# Access Compliance Report

## Public Rights-of-Way

Intersection ID: 26681	Main Street: COUNTRY_LN	Cross Street: LOMA_LINDA_LN	Location: SW
ADA ID: FD7474A22B38	Ramp Type: Perp	Initial Pass/Fail: Fail	Overall Compliance: No
Severity Score: 8.75			
Codes/Mitigation Info/Possible Solution		Field Measurements/Component Compliance

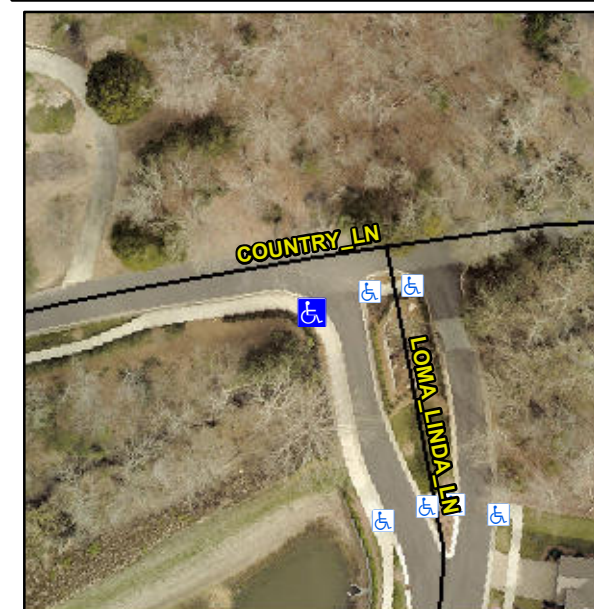
**Remove & Replace Entire Ramp.**

**Not Found, R304.5.1**

Compliance	Description	Data	Compliance	Description	Data
N/A	Ramp Length (in)	85.0	Yes	Ramp Slope (%)	7.8
No	Ramp Width (in)	44.5	Yes	Ramp XSlope (%)	0.1
N/A	Flare Type LT	N/A	N/A	Flare Type RT	N/A
N/A	Flare Slope LT (%)	N/A	N/A	Flare Slope RT (%)	N/A
N/A	Flare Traversable LT?	N/A	N/A	Flare Traversable RT?	N/A
N/A	Landing Length (in)	N/A	N/A	DWS Provided?	N/A
N/A	Landing Width (in)	N/A	N/A	DWS Contrast?	N/A
N/A	Landing Slope (%)	N/A	N/A	DWS Length (in)	N/A
N/A	Landing X Slope (%)	N/A	N/A	DWS Full Width?	N/A
N/A	Landing Curb? (Y/N)	N/A	N/A	DWS Offset (in)	N/A
N/A	Shared Landing?	N/A			
N/A	Gutter Ponding?	N/A	N/A	Gutter Slope (%)	N/A
N/A	Gutter Lip Ht (in)	N/A	N/A	Gutter X Slope (%)	N/A
N/A	Painted X Walk1?	No	N/A	Painted X Walk2?	N/A
	X Walk 1 Direction	To E		X Walk 2 Direction	N/A
N/A	X Walk 1 Width (in)	N/A	N/A	X Walk 2 Width (in)	N/A
	X Walk 1 Slope (%)	1.0		X Walk 2 Slope (%)	N/A
	X Walk 1 X Slope (%)	0.4		X Walk 2 X Slope (%)	N/A
